RE: Aspire School Oakland - Landscaped areas

Aspire Oakland - Soil Management Plan

Thank you again for the productive meeting this morning to discuss the Cap Modification Plan (CMP), dated October 17, 2014, and the CMP Addendum, dated December 4, 2014, for the Former Pacific Electric Motors Facility located at 1009 66th Avenue in Oakland, California. Below is a summary of the CMP sections and modifications made by the CMP Addendum:

FIGURE
2

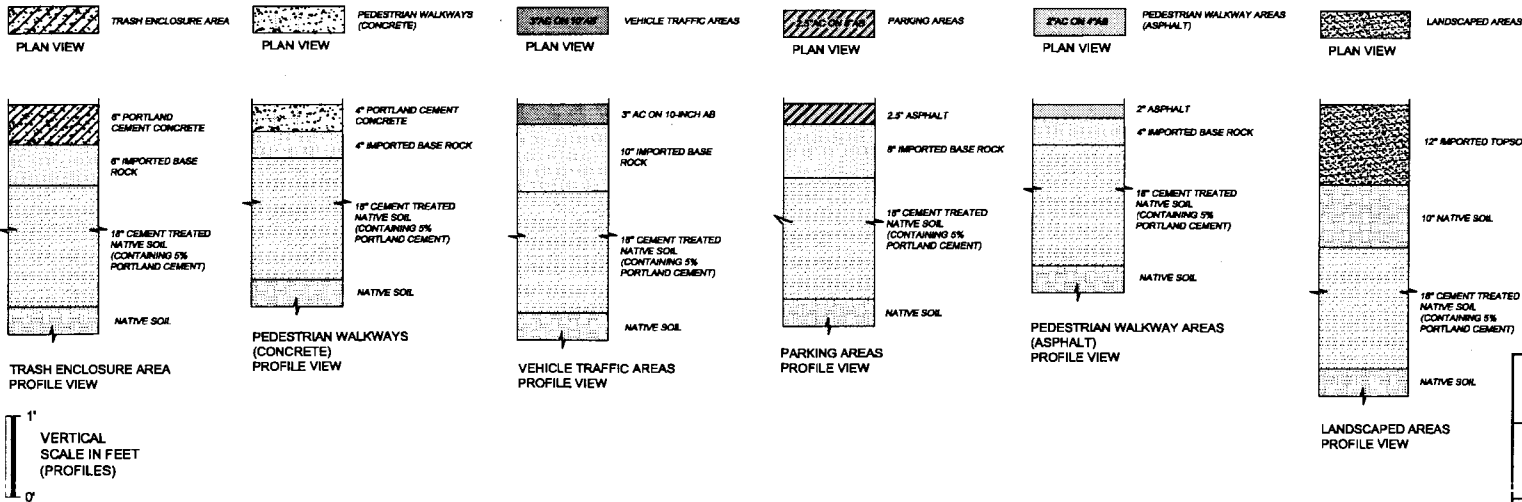
Carmen after some discussions with representatives of Aspire & Pacific Charter School Development we would like to retain the landscaped areas and would like for EPA to consider the following design for the landscaped areas:

Place a geotextile fabric on the cement treated soil (the base of the landscaped areas).

Place approximately 22-inches of imported top soil on top of the geotextile fabric (no reuse of "native" soil)

The attached site plan illustrates the areas of the site that are to be paved. Please note that the attached map still references the original thicknesses, not the proposed intervals provided below. The attached map is intended to illustrate the areas various areas of the site that are referenced below.
